THE	
		NATIONAL	
		ARCHIVES

UNIFIED COMMUNICATIONS

CLARIFICATION QUESTIONS AND RESPONSES

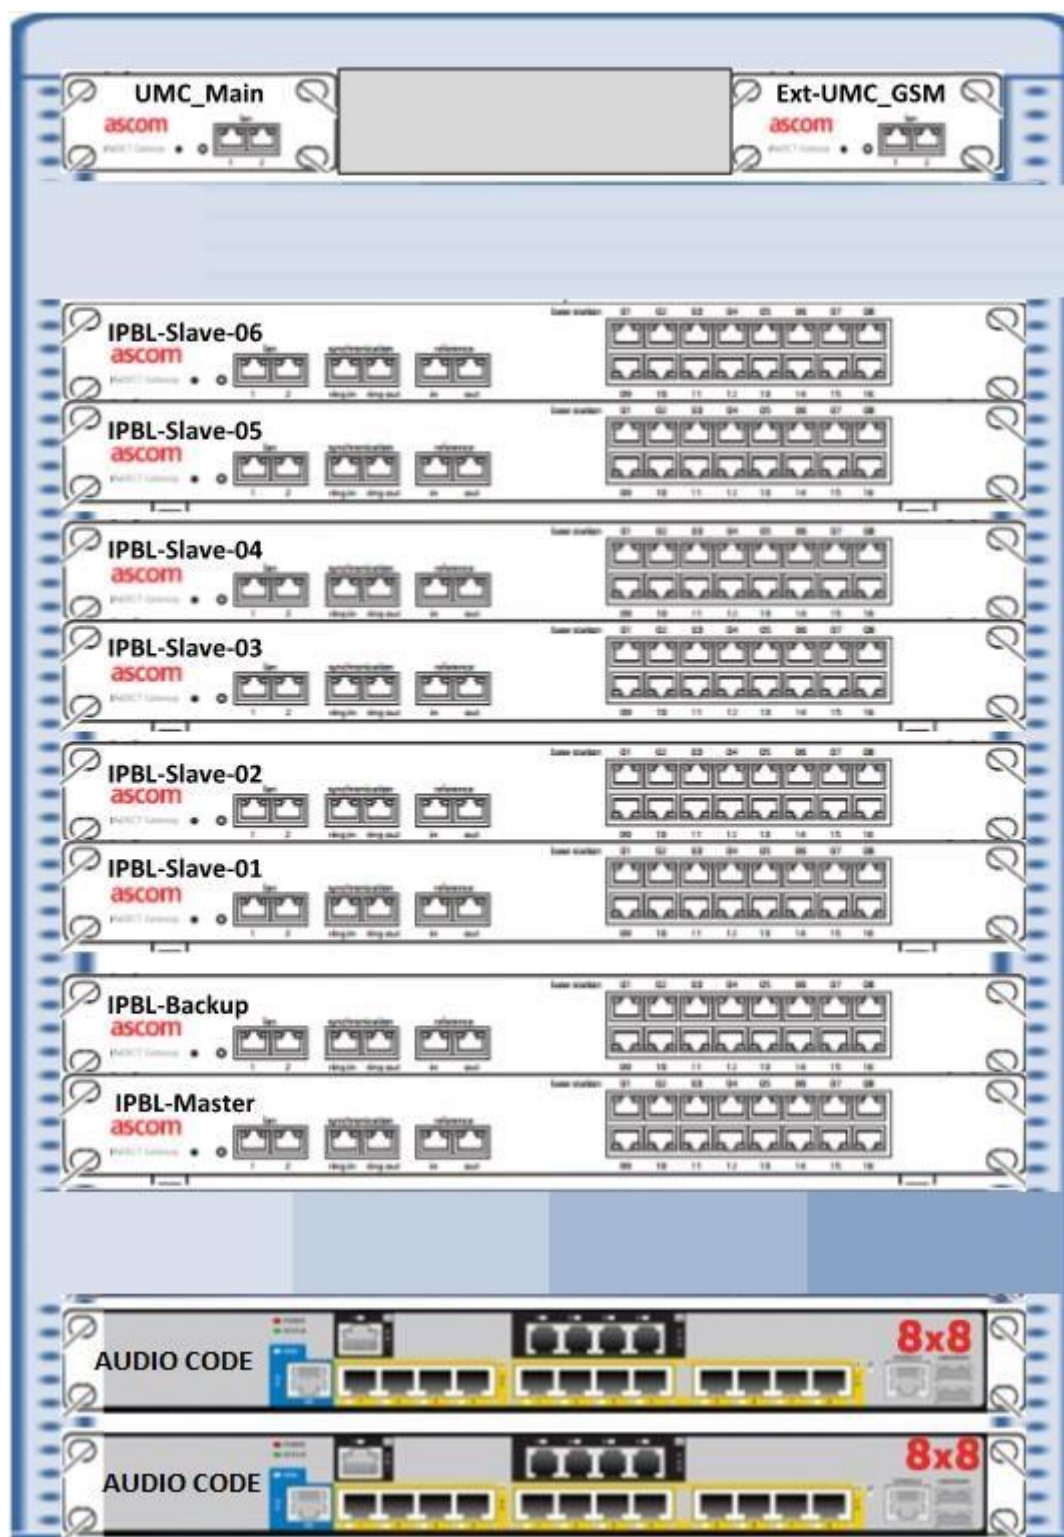
Q9: *Please provide a full list of the hardware included within the DECT Phone infrastructure, highlighting the items that require supporting*

Q42: *Do you have one or two AudioCodes Mediant 800B SBCs? The diagram you provided depicts 2*

Q44: *Do you have one or two AudioCodes MediaPack 124E? The diagram you provided depicts 2*

A9: Please refer to the tender document, specifically paragraphs 2.6, 3.3 and appendices A&B. This diagram shows all the components of the DECT IP infrastructure hardware

A42: Two

A44: Two – see answer to Q.9
